CITY PLAN COMMISSION REPORT

Tiffany Meadows

Case Number: CD-CPC-2022-00050

SITE DEVELOPMENT PLAN & PRELIMINARY PLAT DRAWN BY R.G.Y.

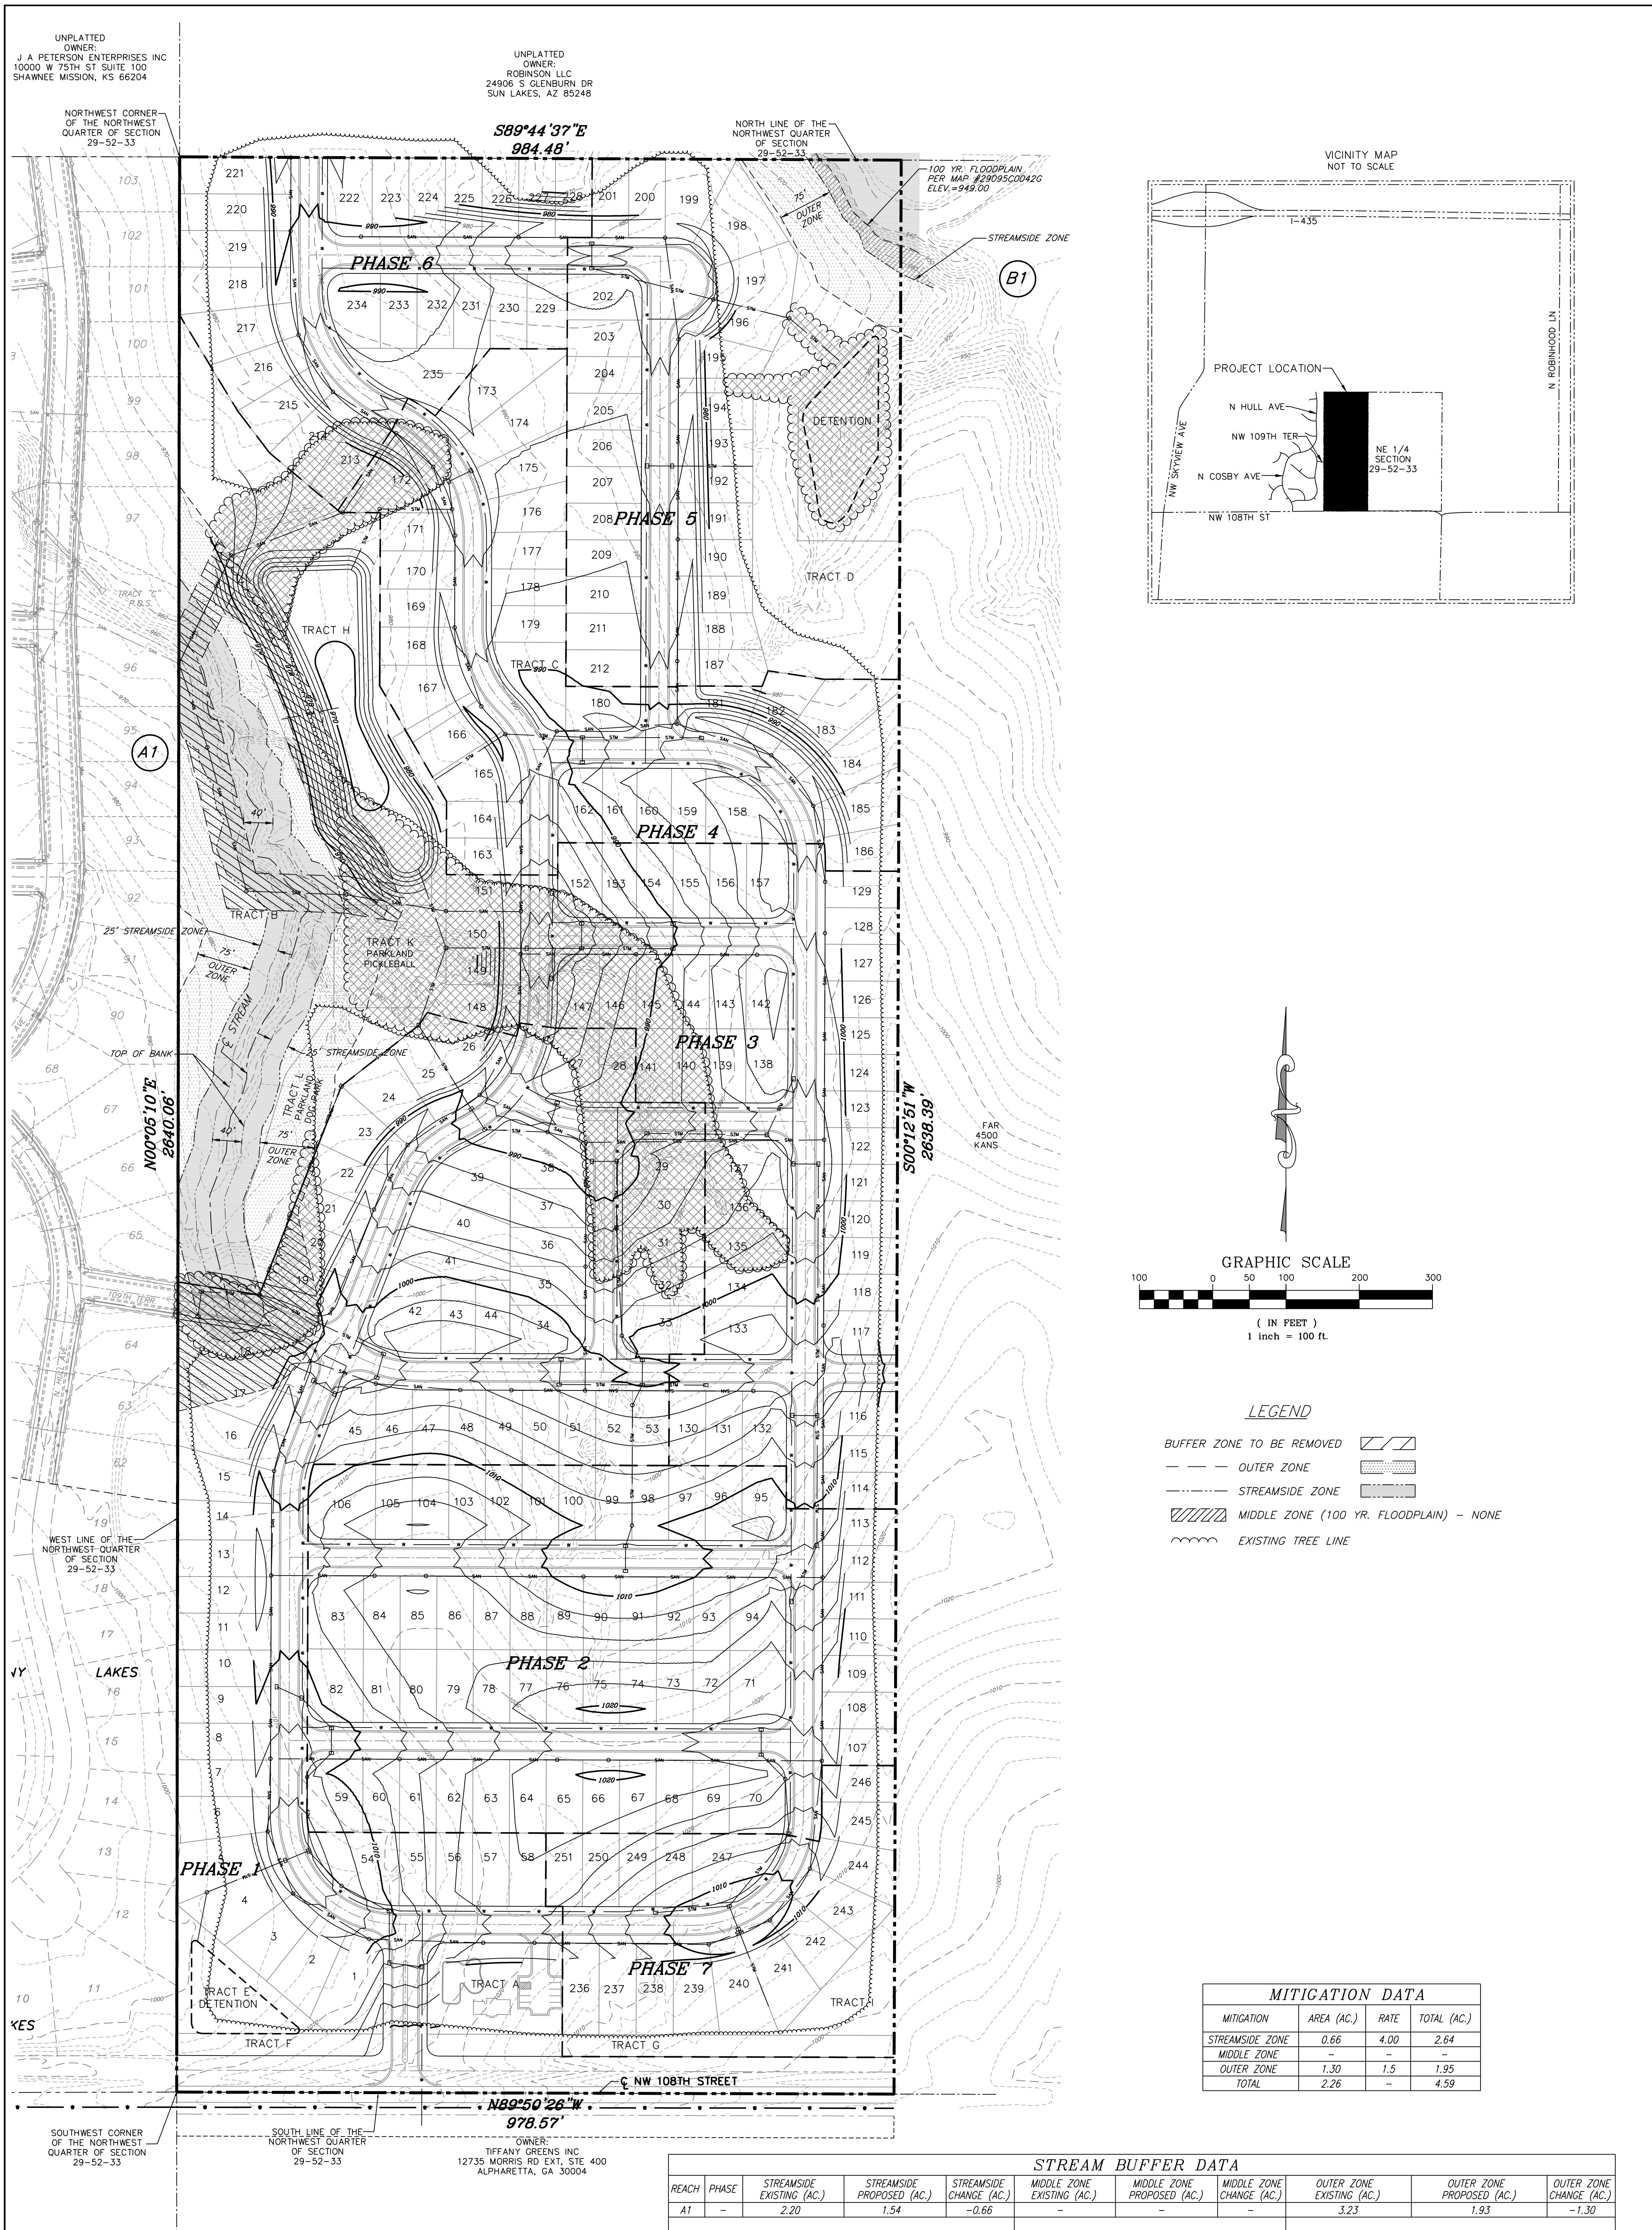
6. Water Services correction from Jerald Windsor stating "Revise the utility plans showing and labeling extension of the existing 24" water transmission main from its current western terminus in NW 108th Street near Cosby Avenue approximately 1650' east to this projects eastern property line. Show and label an exclusive 30' wide water easement for this extension. Pending appropriate approval's its anticipated that WSD will cost-share in the differential cost to upsize this transmission main extension from a 12" to 24"main. Label all water mains sizes, types, as well as public or private. A minimum 12" water main needs to run north/south through the project. Show and label all existing & proposed easements." shall be resolved prior to Ordinance request by Friday June 17th, 2022.

33. The developer must submit water main extension drawings prepared by a registered professional Engineer in Missouri to the main extension desk for review, acceptance and contracts per the KC Water Rules and Regulations for Water main extensions and Relocations.
(<https://www.kcwater.us/wp-content/uploads/2019/04/2018-Rules-and-Regulations-for-Water-Main-Extensions.pdf>)
